ADDENDUM #3

PROJECT: T-2022-PPS06 Nicholson Catholic
College

PROJ. NO.: 21099

DATE: 2022-06-15

DRAWING
DETAIL 1/300 REVISED

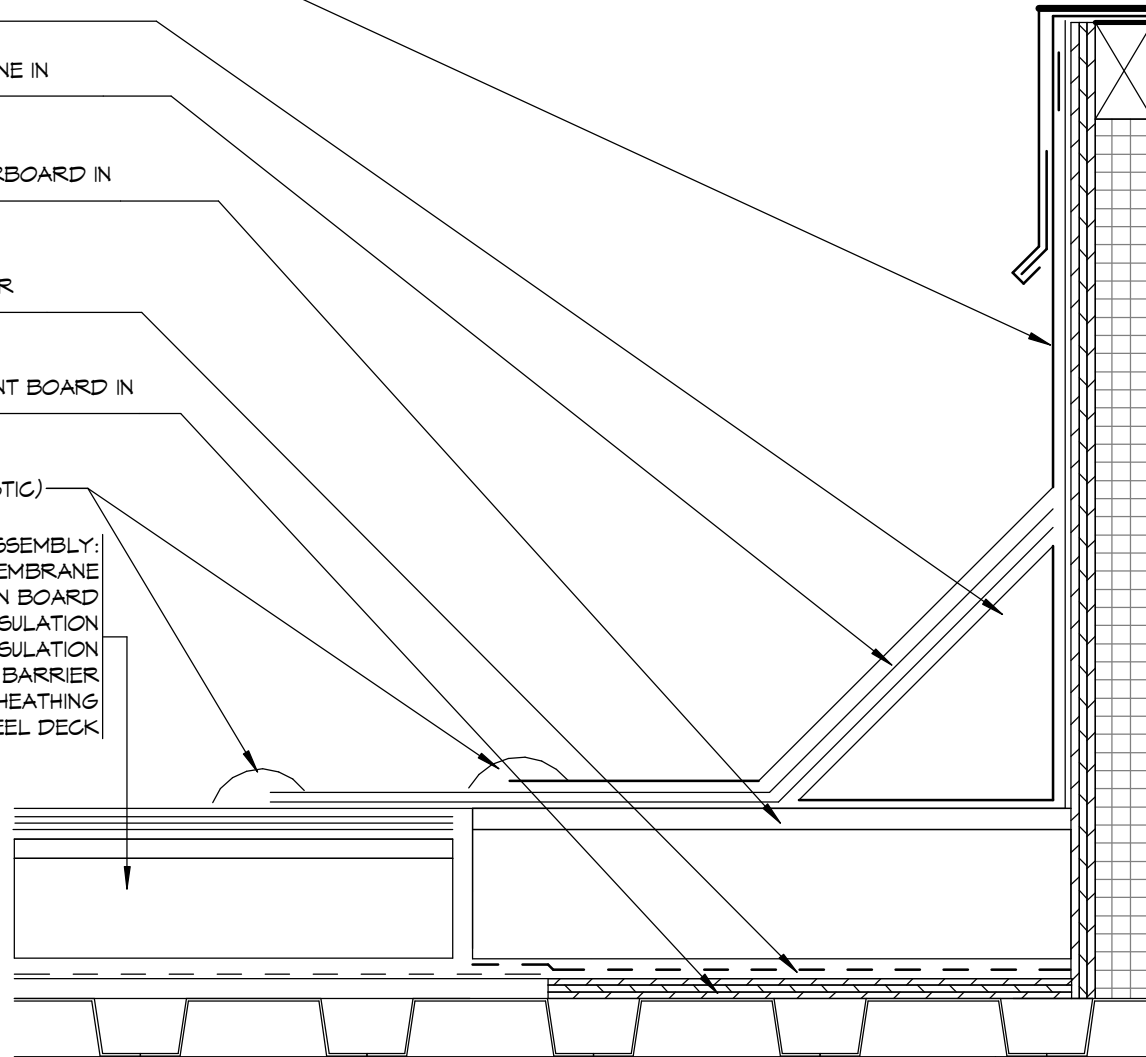
- 3.3 Refer to detail 1 on drawing 300, replace with attached revised detail of roof curb.

- 3.4 SUBJECT: Curb Installation – Built-Up Roof

1. Spud built-up roof top pour back in area of curb installation.
2. Remove top pour down to felts without damaging.
3. Spud back to allow minimum 450 mm tie-in around entire perimeter of curb.
4. Cut roof and remove to allow for curb installation.
5. Exiting roof and facility to be kept free from moisture infiltration at all times.
6. Careful not to damage existing roof.
7. Work area to be protected from material storage at all times.

1. Install new 13mm Dens Deck in beads of lowrise foam adhesive.
2. Install polyisocyanurate min 13mm thicker than existing in beads of lowrise foam adhesive.
3. Install 13mm fibreboard in beads of lowrise foam adhesive.
4. Install two plies Composite Felt HT in Burmastic adhesive extending to top of cant.

5. Install one ply TRA Sheeting adhered in Sheeting Bond. Hand press sheet to ensure full adhesion.
6. Tie-in leading edges of TRA sheeting and membrane extension with Ecomastic/Burmesch.
7. Three course all vertical seams with Polyroof LV/Burmesch/Polyroof LV.
8. Flood coat area with Burmastic adhesive and broadcast aggregate to conceal entire area of work.
9. Paint exposed TRA flashings with Alumanation 301.
10. Clear all debris from site.
